NRC / EPRI Steam Generator Task Force Meeting August 19, 2015

Primary-to-Secondary Leakage Limits

Interim Guidance SGMP-IG-15-01 – In Situ Pressure Test Guidelines, R4

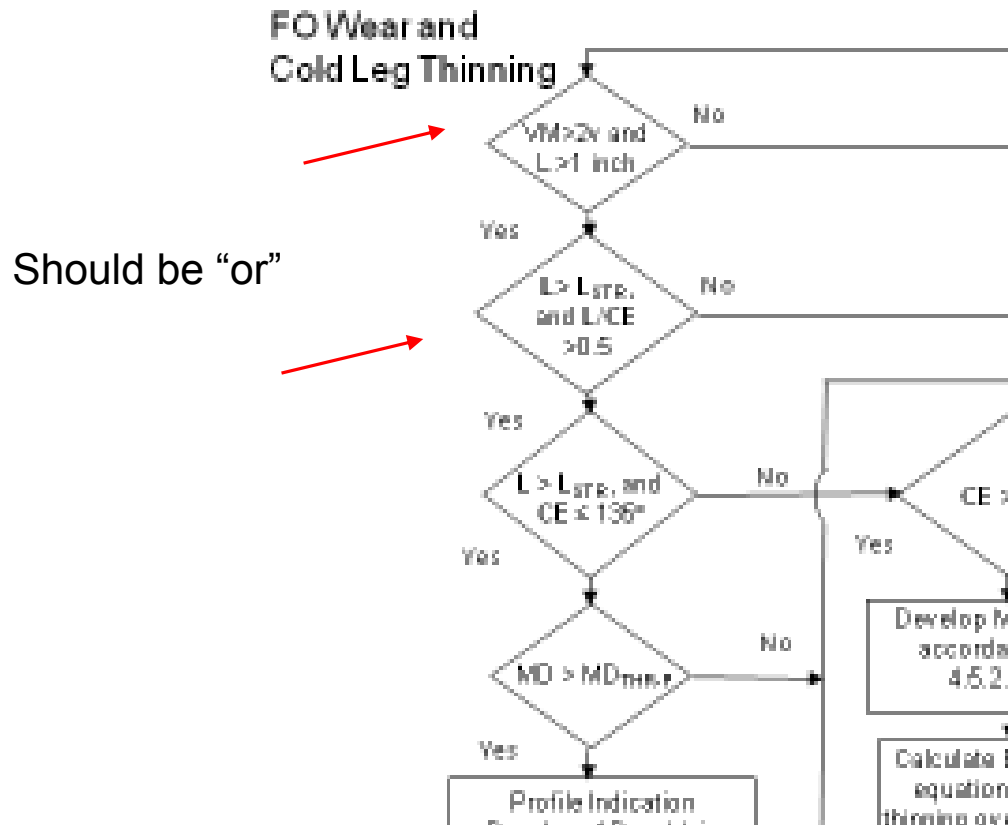
- Error discovered in a flow chart in Section 4
 - First screening level for foreign object wear and cold leg thinning

Wording in the text of the document is correct

- Entered the error into EPRI's Corrective Action Program
 - Notified all members via interim guidance
 - Reviewed Steam Generator Degradation Database for plants that had plugged tubes for foreign object wear or cold leg thinning
 - None of the plants rely on the flow chart alone for screening flaws for in situ pressure testing
 - Document was corrected and reposted to epri.com
